OFFICE OF THE PRINCIPLE CHIEF CONSERVATOR OF FOREST, HOFF, RAJASTHAN, JAIPUR

CCF resubmitted the proposal after amendment corrections. User Agency submits digital maps of the proposal FP/RJ/Road/7000/2014 as per required by MOEF & CC for their letter no.8B/Raj/06/19/2015/FC/1392 dated 4.12.2015. After examination of digital maps some query in the submitted digital maps.

Sheet No 1

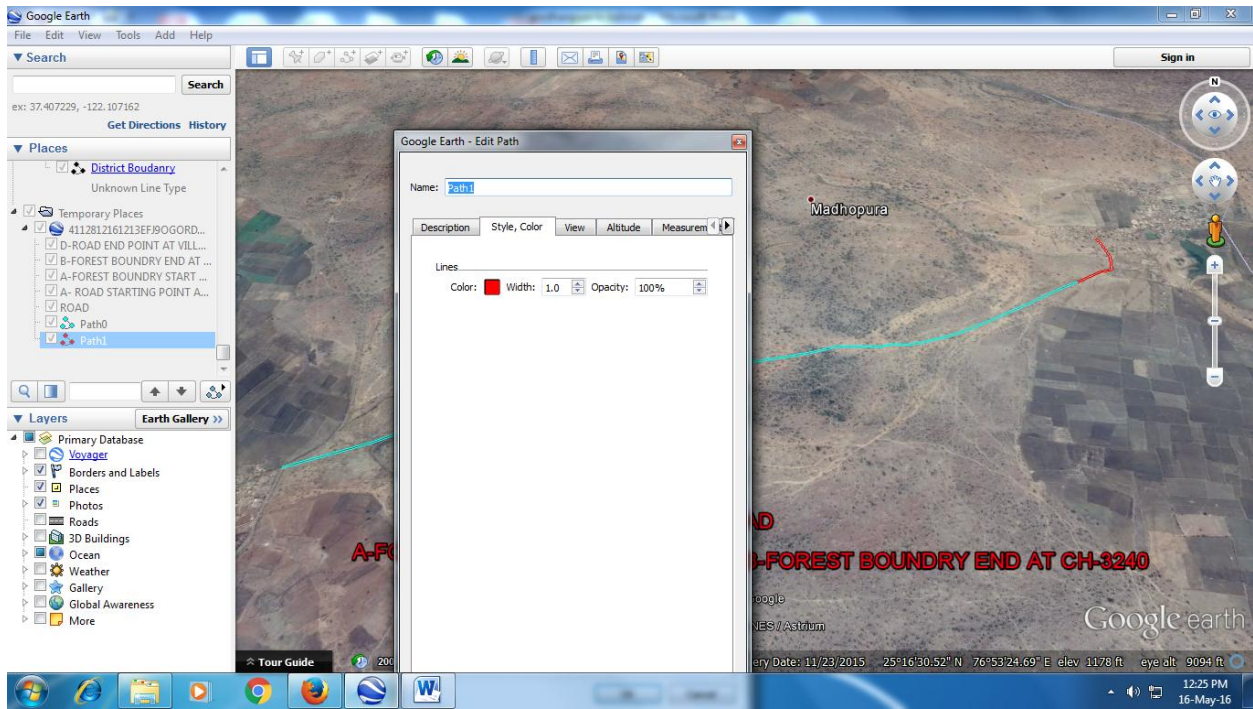
1. Digital Maps are in line shape while MOEF &CC required in polygon shape for DSS analysis.
2. Sheet No 1 expressed that provided digital maps are prepared in path.
3. Sheet no 2 expressed that provided digital maps are in line shape.
4. Sheet No 3 expressed that provided digital maps have a length of 6505 meter in forest while the length of road in forest is only 2980 meter.

Hence, Digital maps are not satisfactory, the proposal is to be forwarded to CCF for modify/ revised digital maps.
